AGENDA
FARRAGUT MUNICIPAL PLANNING COMMISSION

April 20, 2017
7:00 p.m. Farragut Town Hall

**SUBJECT: STAFF COMMENTS ON THE REVISED SITE PLAN FOR THE
DOLLAR GENERAL, 12403 KINGSTON PIKE**

SITE LAYOUT PLAN

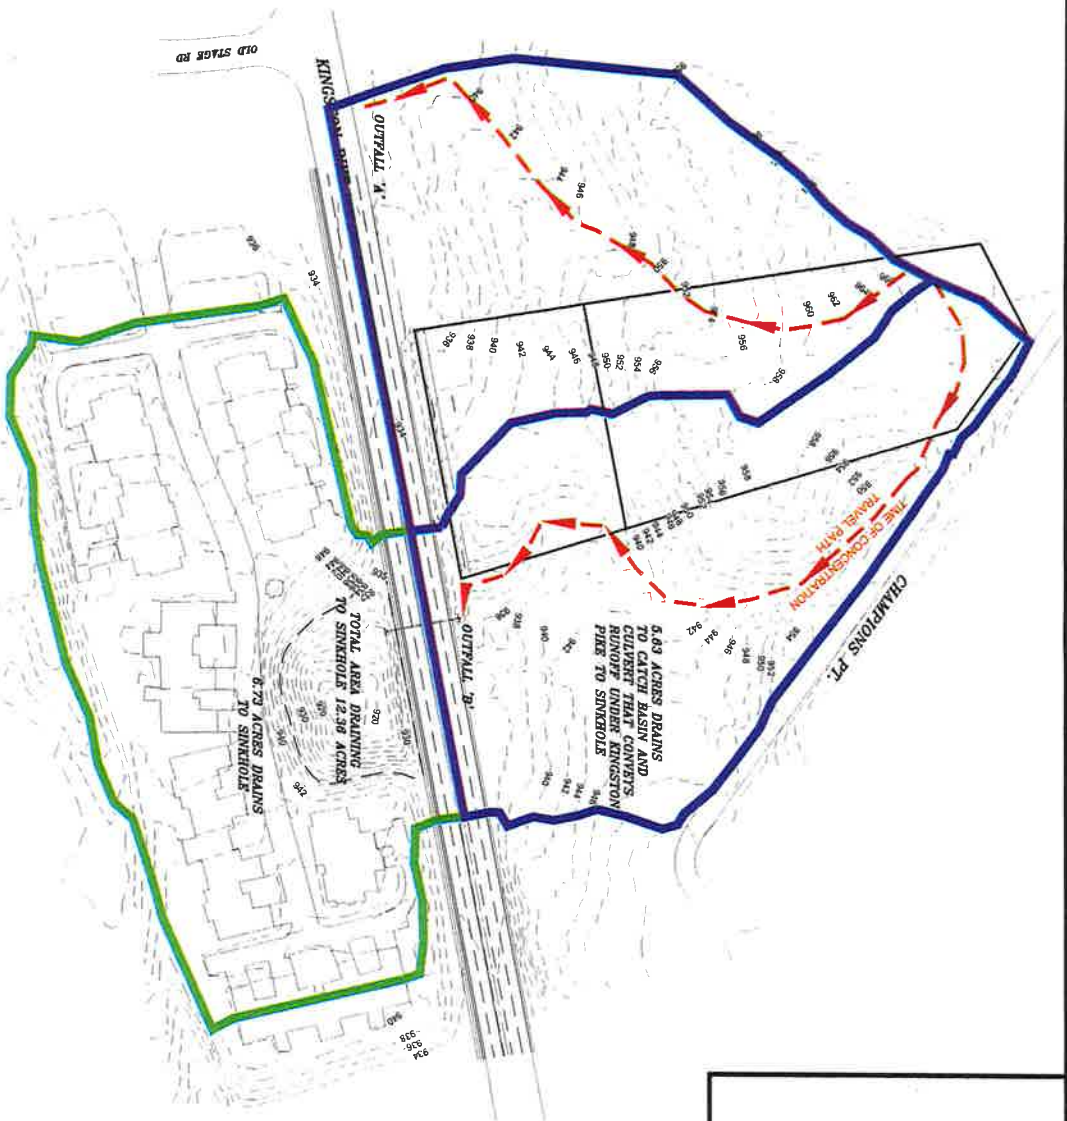
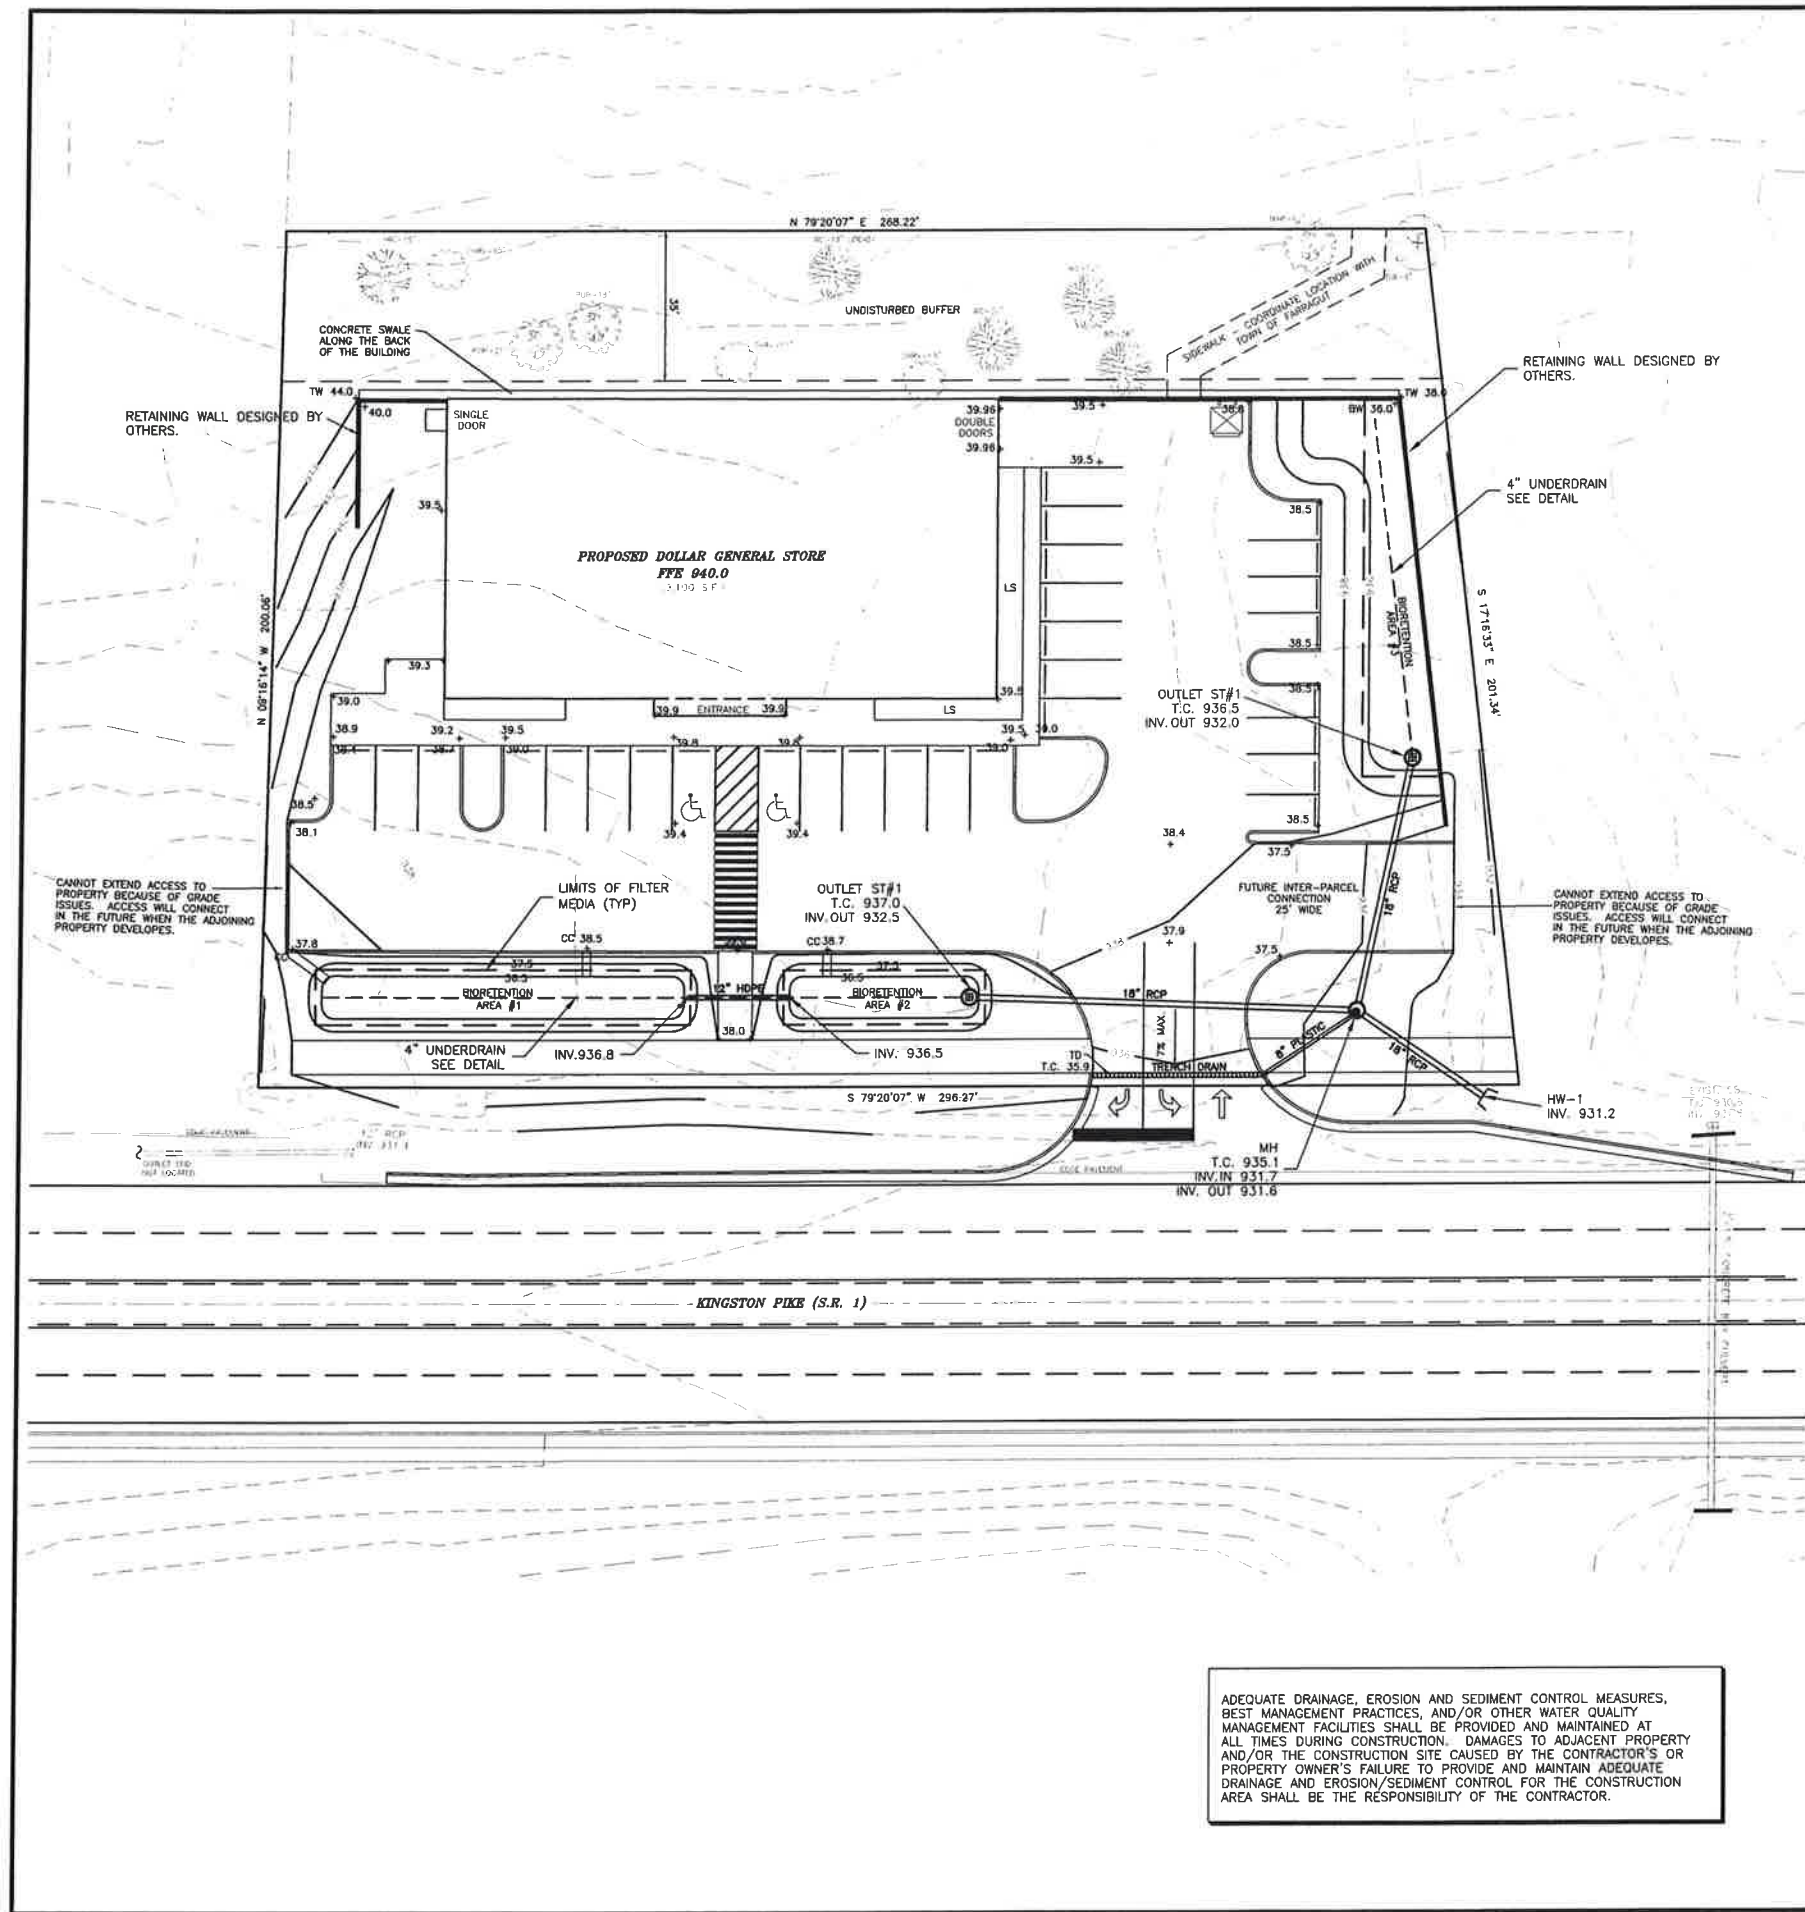
- 13) Please provide construction details and a rendering of the appearance of the proposed retaining walls for the project;
- 14) Please remove all non-regulatory signage from the site plan submittal sheets. Both the monument sign and the wall sign are still shown on different plan sheets;

- d. Standard 2.17 – The revised plan does not include the percentage of masonry that is shown on each building elevation;
- 16) Please extend the vehicular connections to the east and west property lines so that when those properties develop a connection can be made. There is still a gap between the properties and the same entity owns the adjacent property to the west. The staff would recommend (though not require) that the connection be taken to the traffic signal at this time since the same property owner is involved and it would provide for signalized access onto Kingston Pike. As proposed, turning east onto Kingston Pike is not desirable;

- 17) The driveway aisle width that is typical for a commercial project is 24-25 feet. The plans still shows 33 feet and 30 feet. Other projects with large trucks do not require this excessive aisle width for turning purposes and this extra paved area is not consistent with the ADS. Also, lessening these widths to the normal standards would free up more space to improve and increase the amount of landscaping between the building and parking lot and possibly save some larger trees along the sides of the property. Please revise the plan accordingly;

- 18) The depth of parking spaces is 19 feet for standard spaces. The plans show 20 feet. Please add a dimension for the width of the standard and compact parking spaces;

- 21) Please include wheel stops (and a detail for these) where car overhangs could encroach onto pedestrian facilities;
- 22) Please provide verification from TDEC as to whether any portion of a sinkhole extends to this property. If so, the Sinkhole Ordinance will have to be satisfied. The correspondence from TDEC did not specifically address if any portion of the sinkhole is on Lot 1;

- 23) Though the bicycle rack is acceptable, an inverted "U" style is all that is required;
- 24) Please provide for the lot coverage calculations and the percentages;

Tree Preservation / Removal Plan

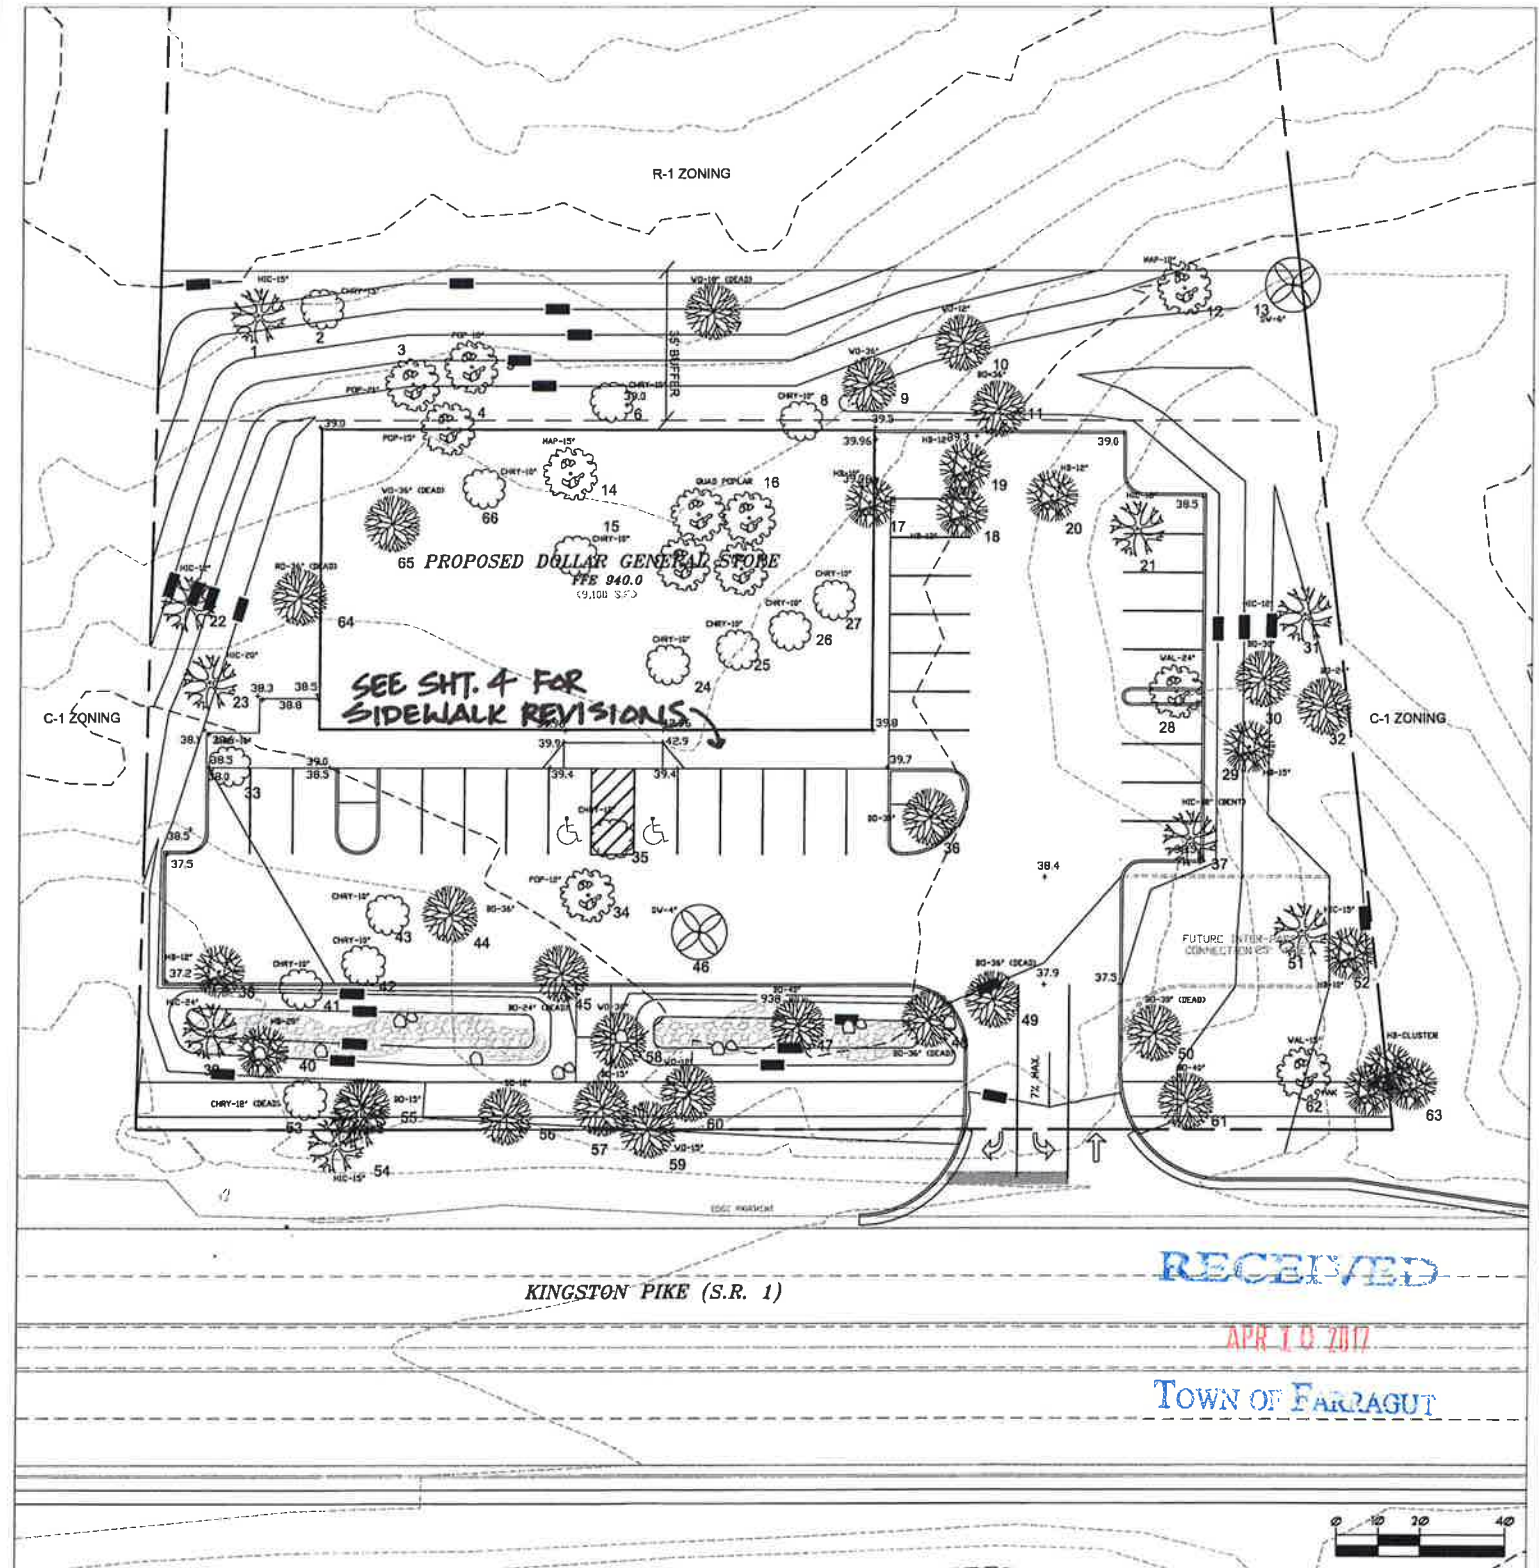
- 25) The landscape plan will be reviewed by the VRRB. A grading permit cannot be issued until the landscape plan is approved;
- 26) Where cut is proposed within the drip line of trees to be saved, an arborist assessment and recommendations are required. Root pruning and possibly other measures may be needed;

Sheet Description :
SITE PHOTOMETRIC

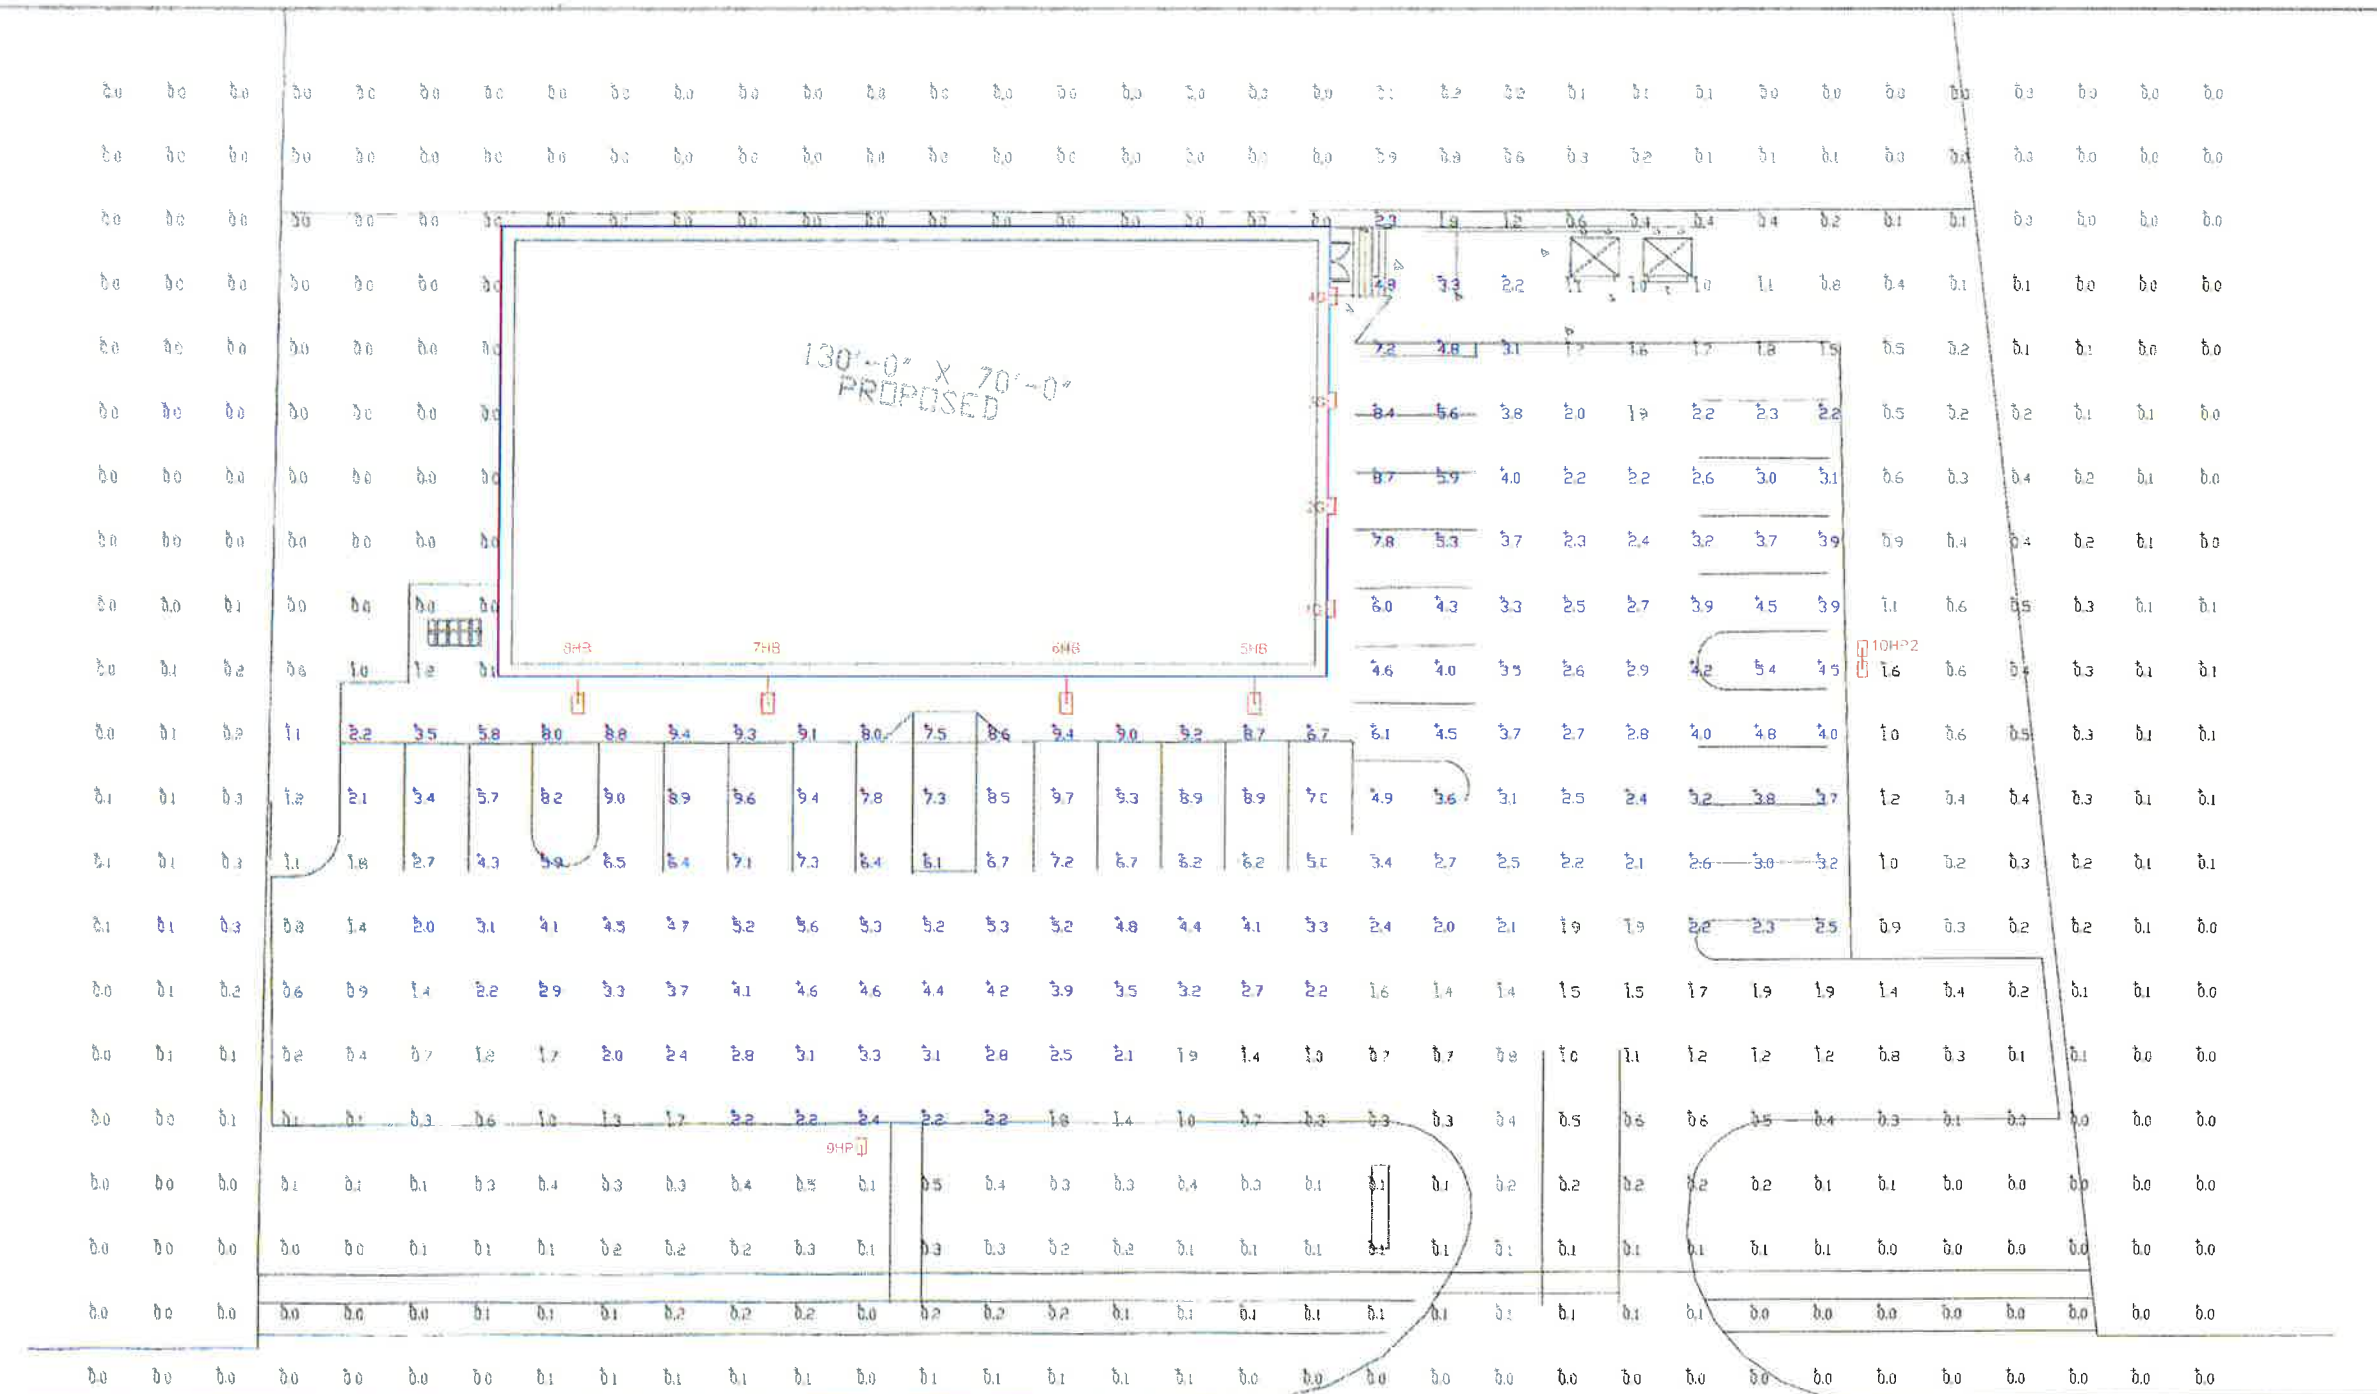
- 12) Please include on the plan sheets (not in handouts that are separate from the sheets) a scaled lighting layout of the site showing the locations of all exterior lights, the height and type of proposed fixtures, and specification sheets for the fixtures and poles that correspond to the lighting layout plan. Interior lighting is not needed on the site plan submittal. Only exterior lighting is needed on the site plan submittal and, when approved, it shall be consistent with the exterior lighting shown on the building plan submittal (if exterior lighting is included on that submittal);
